S A V A N N A H H I S T O R I C D I S T R I C T
B O A R D O F R E V I E W

REQUEST FOR CERTIFICATE OF APPROPRIATENESS

MPC File No.: 26-002466-COA

Address: 512 East Hall Street

1. The 1888 Sanborn, subject property on the left

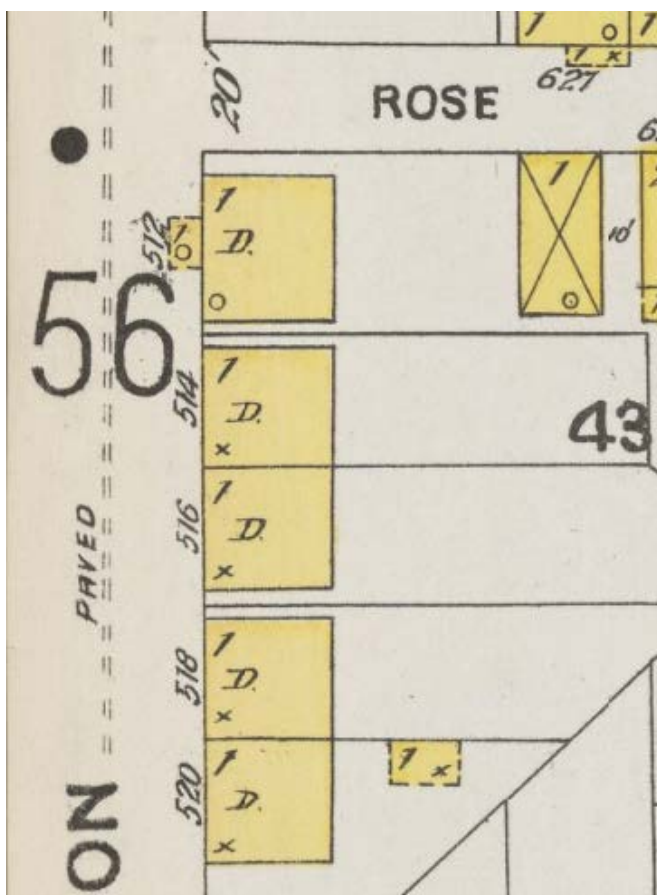
Historic Sanborn Maps show some alterations were made in the years after construction, specifically, a front porch appears in the 1898 map, a rear porch appears in the 1916 map, and the rear porch appears to have been enlarged by the 1955 map. At no point does it specifically show an exterior chimney being added. Additionally, the Cadastral Survey conducted in 1937 shows that there was no exterior chimney at that time. Finally, the Georgia Historic Resources survey, conducted in 2000, notes that the building was renovated and altered in 1960, although it does not provide details on the changes that were made. At some point, the front porch was enlarged and enclosed and the house was covered in a brick veneer, and it is possible that these were the 1960 alterations referenced by the survey, although this is unclear. It is also possible that this is when the chimney was added, but this is also unclear, as the earliest definitive photographic evidence that we have for the existence of the chimney is a 2000 image that was included in the GHR survey. At some point between 2007 and 2012, the porch enclosure and the brick veneer were removed, bringing the house closer to its historic configuration.
